## ADELL CENTER PRO JZ18-24 with Rezoning 18.724

### **ADELL CENTER PRO JZ 18-24 AND ZONING MAP AMENDMENT 18.724**

PLANNING MEMO UPDATE

**TO:** PLANNING COMMISSION  
**FROM:** SRI RAVALI KOMARAGIRI, PLANNER  
**THRU:** BARBARA MCBETH, AICP, CITY PLANNER  
**SUBJECT:** FOLLOW-UP COMMENTS: PROPOSED ADELL DRIVE DESIGN STANDARDS  
**DATE:** JULY 5, 2018

**PRO Concept Plan ( June 04, 2018)**

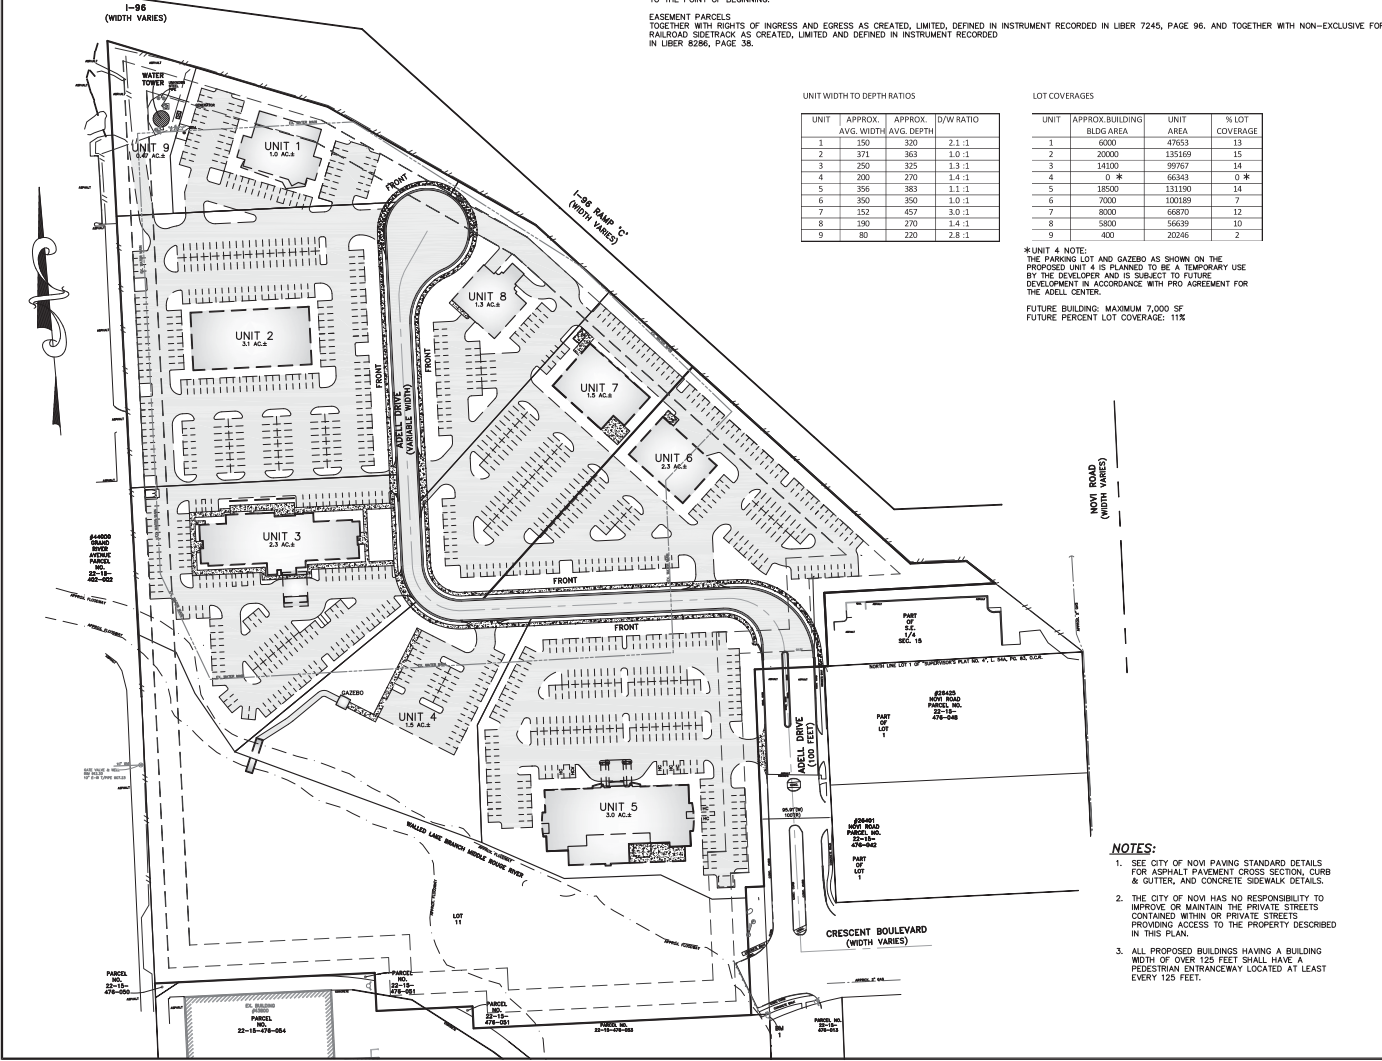
The PRO Concept plan dated June 06, 2018 does not entirely conform to building and parking setbacks as noted in our Planning Review Chart. It should be also noted that the setbacks were proposed to be measured from the edge of proposed 50 feet access easement, which is not the recommended width for access easement for a non-residential collector (70 feet was recommended at that time). All setbacks would be non-compliant if they were measured from the recommended access easement line. Refer to Section 6.3 attached.

The applicant has recently proposed to increase the roadway width to 36 feet (staff's initial recommendation). While this would address most of the Traffic and Engineering concerns with regard to the *pavement width*, Planning is concerned that it seems likely at this point that changing that width might also impact some *other* aspects of the PRO Concept Plan that are not an issue at the moment. The applicant has stated that the current unit boundaries have been mutually agreed upon with purchasers and we understand from conversations that the applicant is reluctant to make major layout changes. We are not clear how the widening of the road width would affect things like the setbacks and greenbelt width, etc. **Thus, the impacts on other aspects of the plan of widening pavement for the road to 36 feet wide are undetermined at this time.**

**In order to confirm the appropriateness of a pavement width of 30 feet as currently indicated on the PRO Concept Plan, the applicant should provide additional supplemental information requested in e-mail dated July 3, 2018.**

Based on the items discussed in this memo, staff has determined that a range can be established between these two standards (Sec. 5.10 and Sec. 11-198) to provide the applicant with some flexibility for design standards. **Staff recommends (1) that a hypothetical 60 foot wide access easement as described in the ordinance be shown on a revised PRO Concept Plan to assist in determining whether additional or fewer deviations should be requested, and (2) that the road and the hypothetical easement area be provided as part of the PRO in a manner consistent with the ordinance.**

**If the applicant decides to instead show a pavement width of 36 feet, the applicant should provide a revised Concept Plan so that the staff can review and identify conformance to ordinance standards.**

**Figure 1.** City of Novi Regulated Wetland & Woodland Map (approximate parcel boundary shown in orange). Regulated Woodland areas are shown in green and regulated Wetland areas are shown in blue.

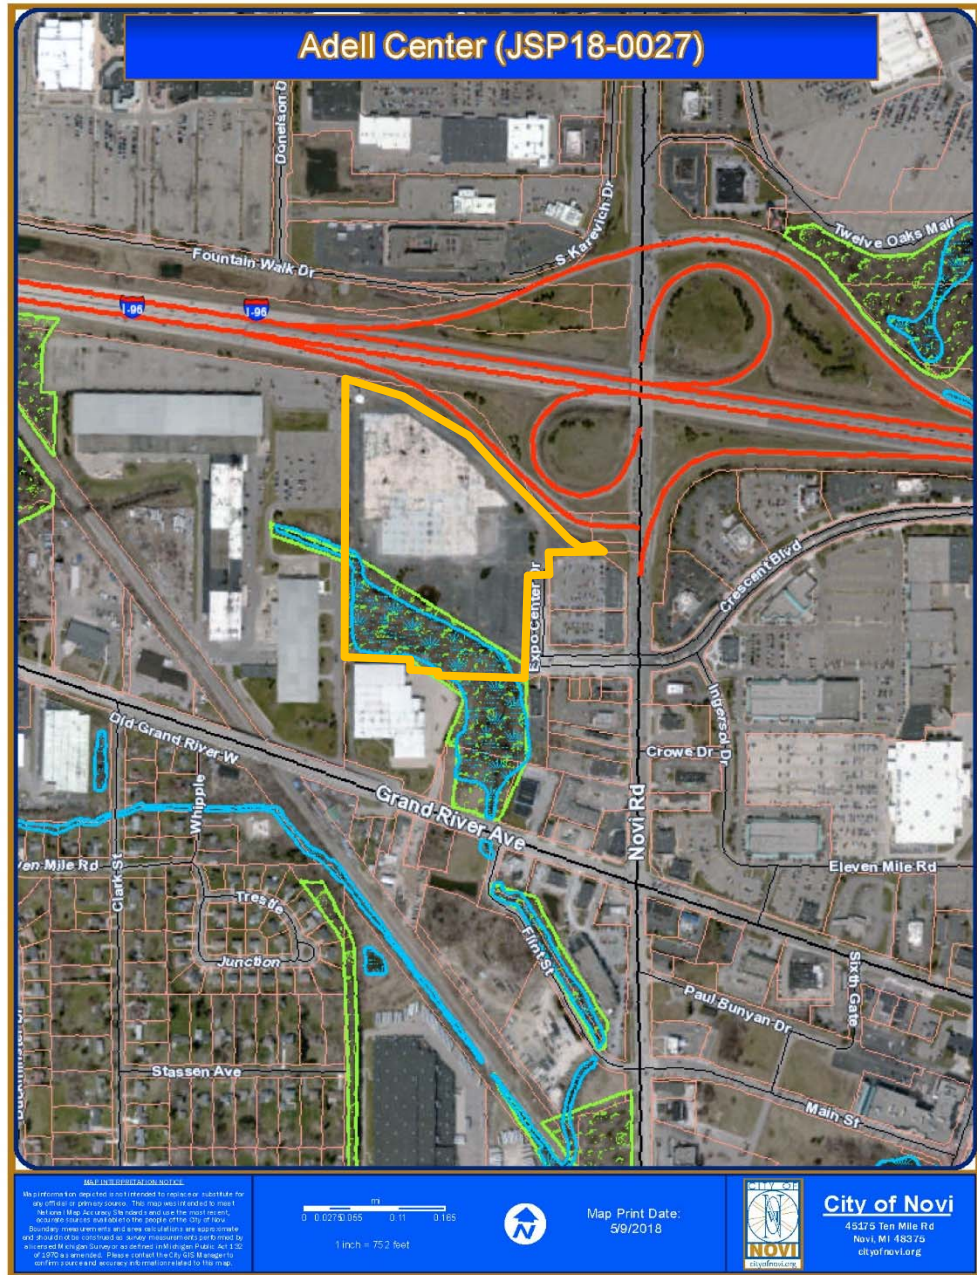
ECT's in-office review of available materials included the City of Novi Regulated Wetland and Watercourse map (see Figure 1), USGS topographic quadrangle map, NRCS soils map, USFWS National Wetland Inventory map, and historical aerial photographs (from Oakland County). Based on our review of this information the overall proposed project parcel contains areas mapped as City-Regulated Wetlands/Watercourses. The site appears to contain wetland/watercourse areas that are regulated by the City of Novi as well as the Michigan Department of Environmental Quality (MDEQ).

All six (6) of the on-site wetlands appear to be located within the area depicted as regulated wetland on the City of Novi Regulated Wetland and Watercourse Map (Figure 2). ECT has evaluated each wetland and believes that each wetland is regulated by the City's Wetland and Watercourse Protection Ordinance because all on-site wetlands are located within 500-feet of the Walled Lake Branch of the Middle Rouge River.

Figure 2. Wetland Sketch (provided by BWA).

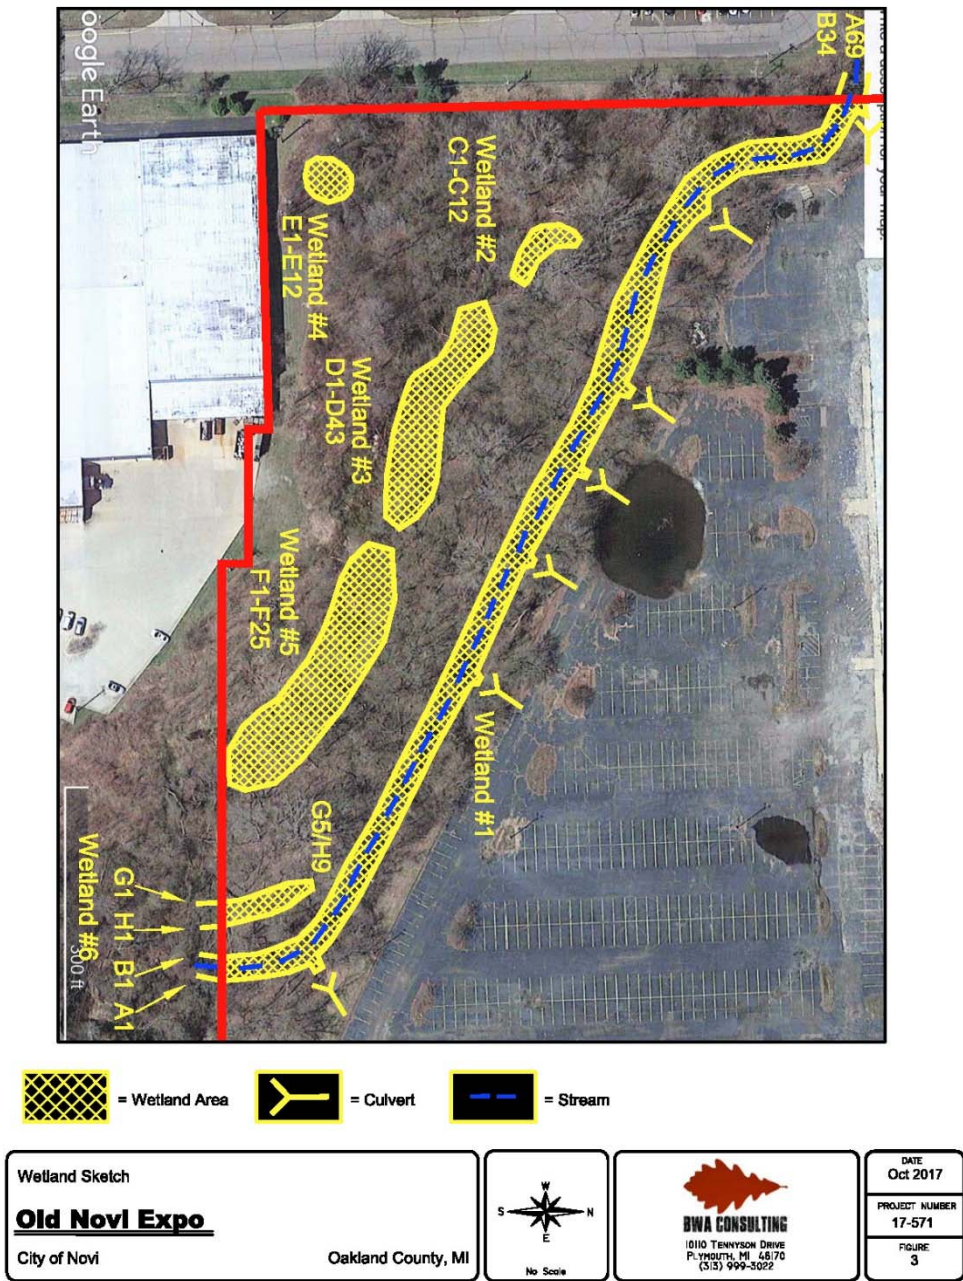
The BWA Report notes that a total of six (6) wetlands were identified. The following is a brief description of the on-site wetland features (see Figure 2 provided by BWA):

ECT has evaluated the on-site wetlands and believes that they are all considered to be essential/regulated by the City of Novi as they meet one or more of the essentiality criteria (i.e., functions and values) outlined in the City of Novi Wetland and Watercourse Protection Ordinance and regulated by the MDEQ. As noted, the wetlands appear to accurately flagged in the field and appear to be generally indicated accurately on the *Wetland Sketch* provided by BWA (Figure 2, attached).

**Figure 1.** City of Novi Regulated Wetland & Woodland Map (approximate parcel boundary shown in orange). Regulated Woodland areas are shown in green and regulated Wetland areas are shown in blue.

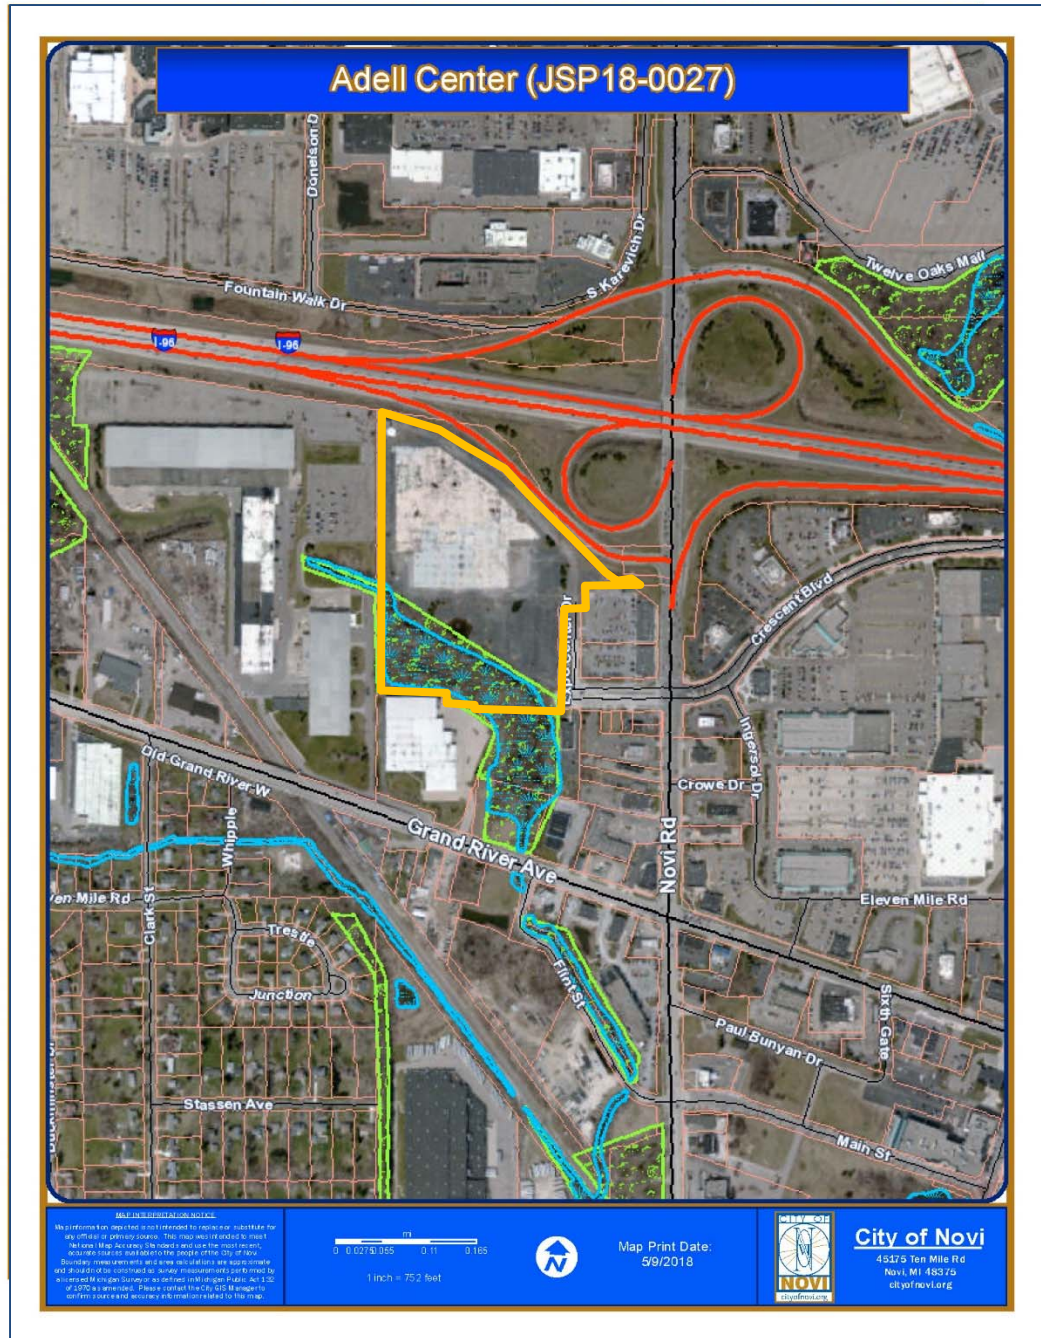
Based on our review of the Plan, Novi aerial photos, Novi GIS, City of Novi Official Wetlands and Woodlands Map (see Figure 1), and on-site evaluation this proposed project site contains areas indicated as Regulated Woodlands as well as Regulated Wetlands. The area of regulated woodland encompasses approximately the southern portion of the project property (south of the Walled Lake Branch of the Middle Rouge River).
